29/6-1-97A 11231 River View Driv  
Potomac (MP Site #29/6-1)

Case No: 29/6-1-97A      Received December 19, 1996

Application of Dr. Yonus Zegeye

**DECISION AND OPINION OF THE COMMISSION**

**NEW DOORS AND WINDOWS**  
3/8" x 1'-0"

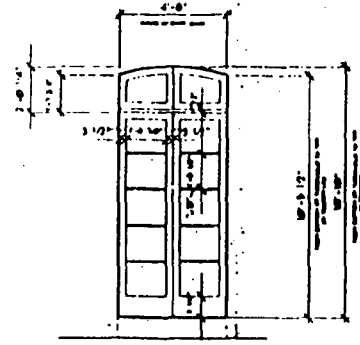
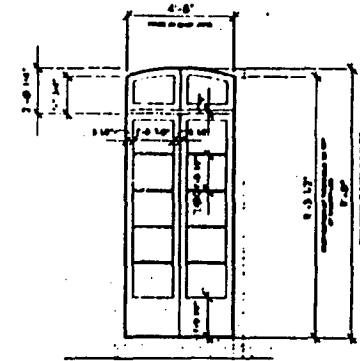
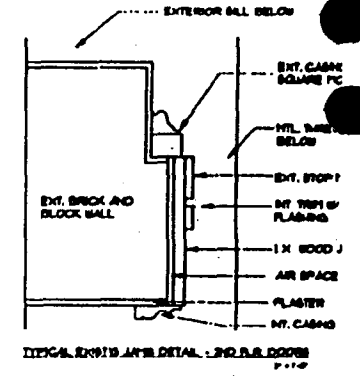
Commissioner Kousoulas assured him that modern glass could be used to replace broken or missing panes. He went on to express his concern that, because the application was to use two layers of glass, the new windows would require thicker muntins and would lose the design

The applicant proposes to replace all existing windows and doors with custom-milled double-glazed windows and doors constructed from mahogany wood and designed as closely as possible to replicate existing windows and doors. The major difference in the new windows would be that the muntins would have to be thicker/wider than the originals to contain the double-glazed glass panes.

3. The proposal to replace all the original and historic windows and doors constitutes a change that significantly impairs Marwood's significant architectural features. Total replacement of windows and doors is typically not permitted because windows and doors are an essential part of the architectural fabric of a building. The goal of historic preservation is not to only keep the general exterior appearance of the historic building intact, but also to **preserve** the actual materials and architectural components of a structure so that future generations can appreciate the original building - not a substantially replicated building.
